# UNITED STATES PATENT AND TRADEMARK OFFICE

APPLICATION NO.	FILING DATE	FIRST NAMED INVENTOR	ATTORNEY DOCKET NO.	CONFIRMATION NO.
10/027,389	12/21/2001	Ronald E. Cole	1007-0542 / M7273.1	1177

**Office Action Summary**

### **DETAILED ACTION**

Figure 1

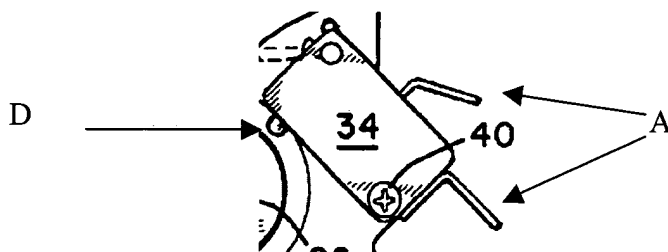
6. Claims 8-41 are rejected under 35 U.S.C. 103(a) as being unpatentable over Swartzell (U.S. Patent No. 6,315,336) in view of Barnett (U.S. Patent No. 4,374,320). In regards to claims 8-10, Swartzell discloses a support (10; col. 3, line 21) adapted to be mounted to a self-cleaning oven (see Title); a cam (26; col. 3, line 36) maintained by said support; a cam plate (generally 32; see col. 4, line 11) coupled to said cam and driven by said cam; a motor (24; col. 3, line 36) coupled to said cam (26) and operative to drive said cam; a latch mechanism (14; col. 3, lines 30-40) coupled to and driven by said motor; a plurality of switches (34,36 & 54; col. 4, lines 10-20)

maintained on said support and selectively actuated by said cam plate, see col. 4, lines 10-14; a plurality of terminals (A) associated with said plurality of switches and maintained on said support (10). Swartzell does not positively disclose that the plurality of terminals are configured to connect to a single terminal interface, however, it is disclosed that said switches are connected to the over control. Barnett discloses a motorized over door latch control that teaches the use of a switch (200) having a plural sets of terminals configured to connect to a single quick-connect terminal interface.

In regards to claims 11 and 18, one of Swartzell's plurality of switches includes a door position switch (54; see col. 4, lines 15-16). In regards to claims 12 and 19, at least some of said plurality of switches (34 & 36) are actuated by cam (26; see col. 4, lines 10-15). As it concerns claims 13 and 20, Swartzell further comprises a flat cam plate (generally 32) in communication with and driven by said cam, said flat cam plate in communication with at least some of said plurality of switches (34 & 36; see col. 4, line 12). In regards to claims 14-17, the Swartzell and Barnett references disclose a door latch mechanism for a self-cleaning over comprising a support (10), a rotating cam (26), a motor (24), a cam plate (generally 32), a latch mechanism (14), a plurality of switches (34, 36, & 54), a plurality of terminals (A) associated with said plurality of switches, wherein said plurality of terminals are ganged to permit connection to a single point terminal connector as set forth above. In regards to claim 21, Swartzell discloses a latch

assembly for a self-cleaning oven (see Title), comprising a support (10; col. 3, line 21); a motor supported by said support (24; col. 3, line 36); a cam (26; col. 3, line 35) driven by said motor (24); a latch mechanism (14; col. 3, lines 30-40) driven by said motor (24); a plurality of switches (34 & 36; col. 4, lines 10-20) supported by said support (10; see Figs. 1-2), wherein movement of said cam (26) via lobe (32) causes actuation of at least one of at least one of plurality of switches (34 & 36); see col. 4, lines 10-14. In regards to claim 22, the Swartzell reference further comprises an intermediate cam structure mechanically interposed between said cam and said plurality of switches. As it concerns claim 23, movement of cam (26) causes movement of said intermediate cam structure (i.e., cam lobe (32)), and movement of said intermediate cam structure causes actuation of said at least one of said plurality of switches, see col. 4, lines 10-15. In regards to claim 24, said intermediate cam structure includes a cam follower (i.e., cam lobe (32)) which is caused to move in response to movement of said cam, see col. 3, lines 38-40. As it concerns claim 25, said cam follower includes a cam plate (see Fig. 1) having a plurality of tracks, and a plurality of switch actuators (D in Fig 1' above) respectively disposed within said plurality of tracks. In regards to claim 26, said cam follower (32) includes a cam plate (i.e., generally 26) having an opening (30) defined therein and said cam extends through said opening. As it concerns claim 27, said plurality of switch actuators (D) are respectively movably settable along said plurality of tracks. In regards to claims 28 and 29, said plurality of switches includes an upper set of switch arms (34) and a lower set of switch arms (36), and movement said cam causes at least one upper arm of said upper set of switch arms and a respective at least one lower arm of said lower set of switch arms to contact each other. As it concerns claim 21, said support (10) includes a housing having an opening defined therein (see

Fig. 1), said latch mechanism (14) is position in said housing, said latch mechanism includes a latch arm that extends through said opening defined in said housing (i.e., the opening near 18). Claims 31-41 recite claim subject matter having the same limitations as claims 8-30 and rejected accordingly as set forth above.
